# 109 Albert Street - 2022/2135/L

<b>Delegated Report</b>  (Members Briefing)		<b>Analysis sheet</b>		<b>Expiry Date:</b>	26/02/2024
		N/A		<b>Consultation Expiry Date:</b>	N/A
<b>Officer</b>			<b>Application Number(s)</b>		
Sonia Cupid			2022/2135/L		
<b>Application Address</b>			<b>Drawing Numbers</b>		
109 Albert Street London NW1 7NB			See decision notice		
<b>PO 3/4</b>	<b>Area Team Signature</b>	<b>C&amp;UD</b>	<b>Authorised Officer Signature</b>		
<b>Proposal(s)</b>					
Replacement of rear double door and single rear window with two windows at ground floor level and internal alterations.					
<b>Recommendation(s):</b>		Grant conditional consent			
<b>Application Type:</b>		Listed Building Consent

### 3. Existing Floor Plans

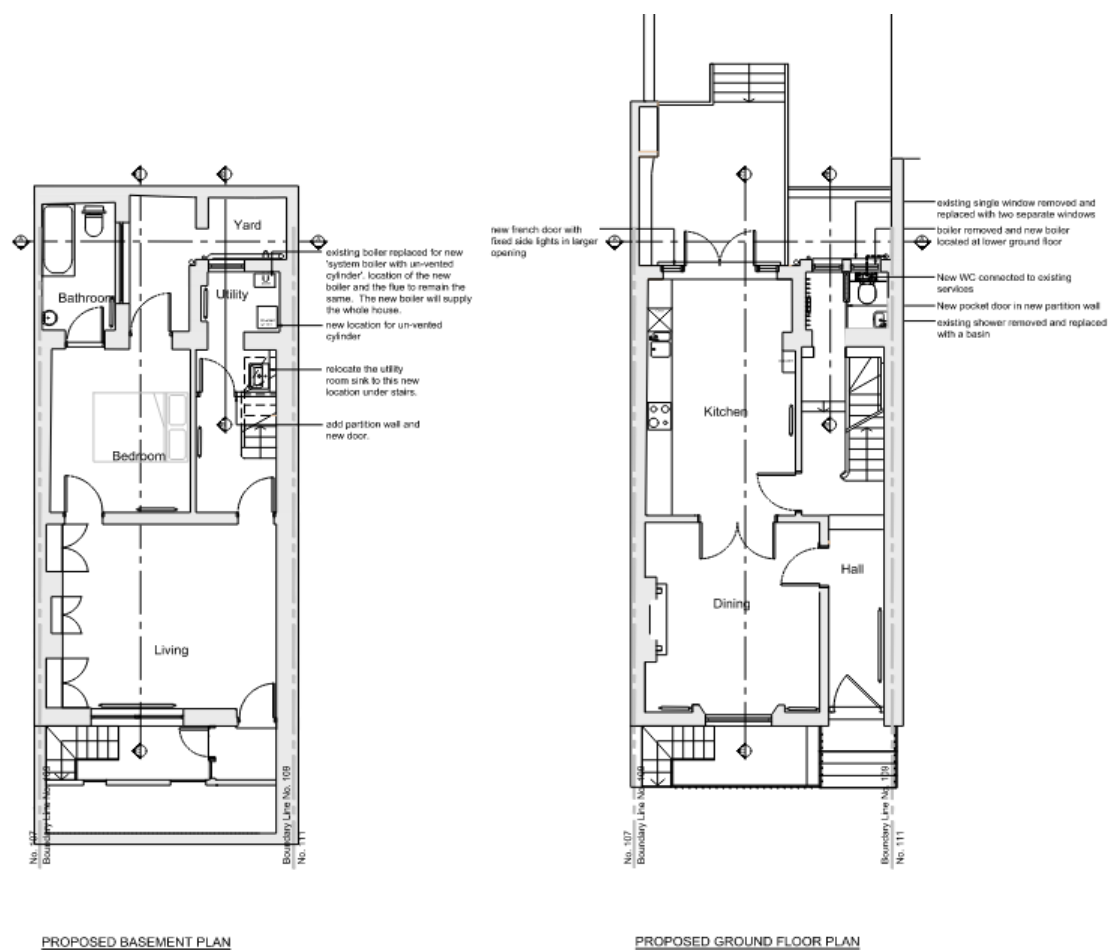
2.1.6. The existing window and doors form part of a non-original extension to the building. The fenestration is therefore non-original and their design is not in keeping with the fenestration of the building. Therefore, the loss of these features is considered acceptable.

### 4. Proposed Floor Plans

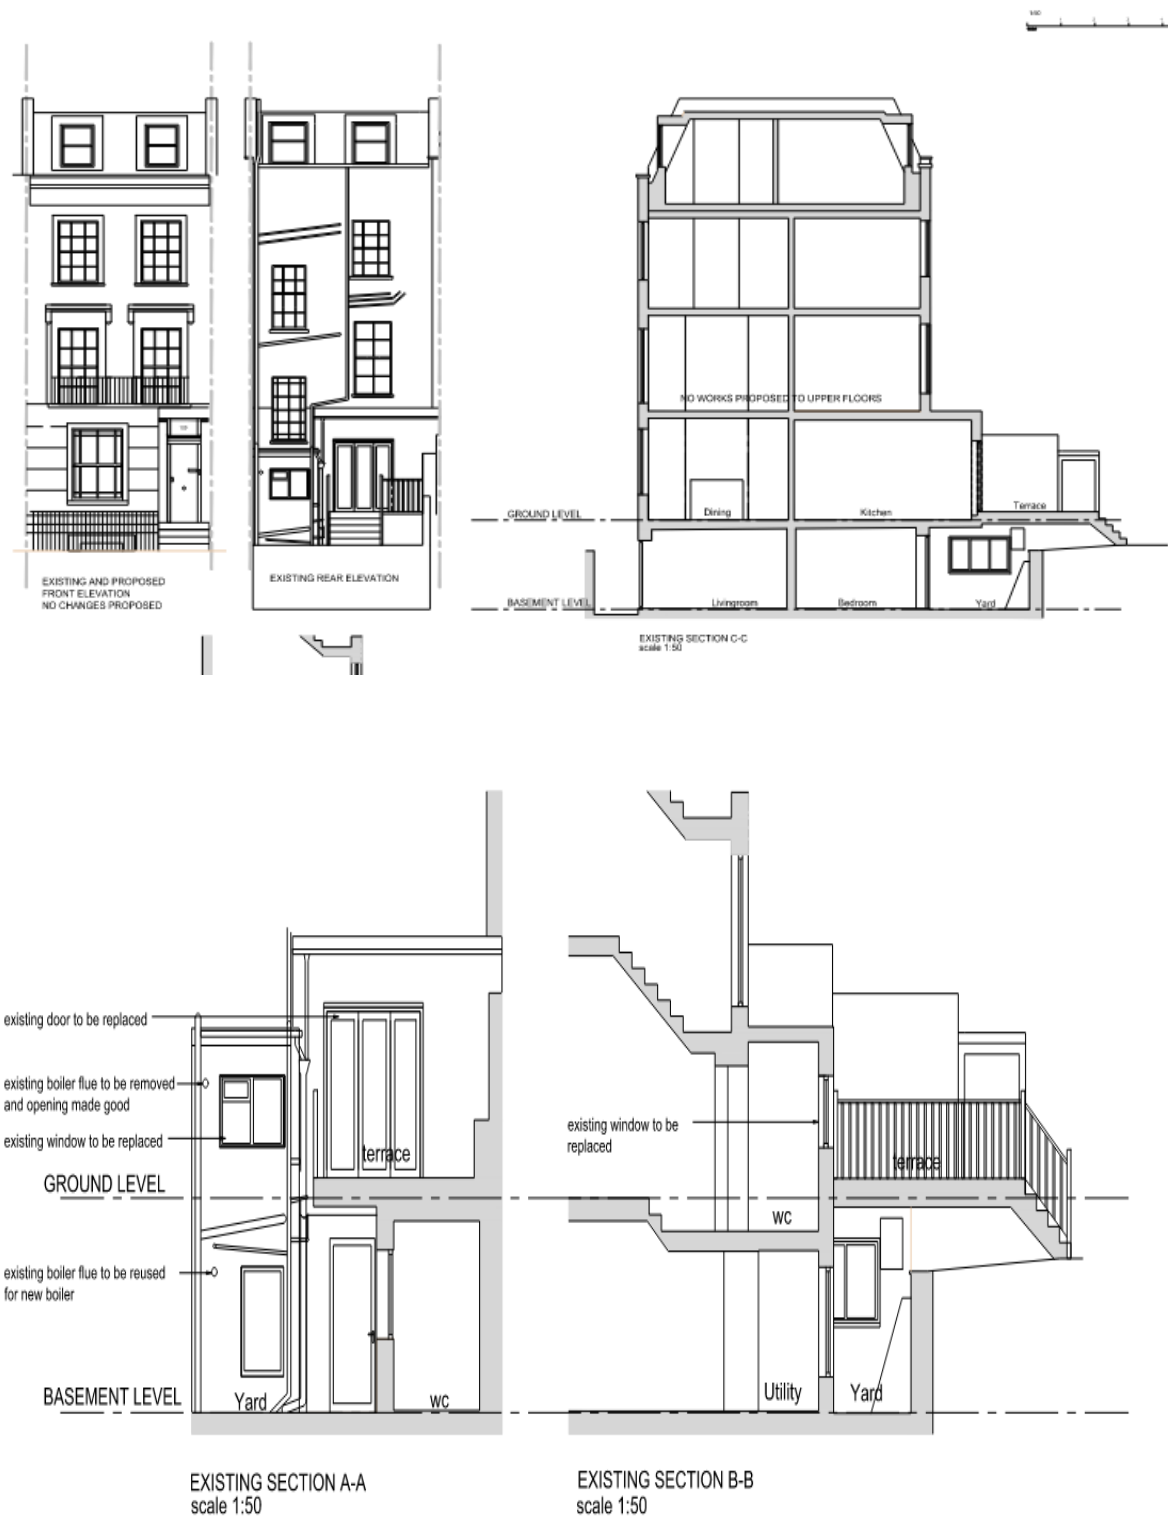
2.1.4. The proposal is to replace the single glazed timber window and door at ground floor level on the rear elevation with a new timber French doors and fixed side lights and two double glazed timber sash windows. Internally the proposal also includes a basement level utility, and reconfigured WC/shower room at ground floor.

2.2.1. Internally located at secondary basement level, the proposed additional partition and door added in the hallway to create a utility room under the stairs is not considered to pose harm to significant planform or fabric. Alterations to the existing shower to create a WC are confined within a later rear addition and would also not impact historic fabric. With the previously proposed relocation of the kitchen to the front dining room omitted, the works are now considered supportable from a heritage perspective.
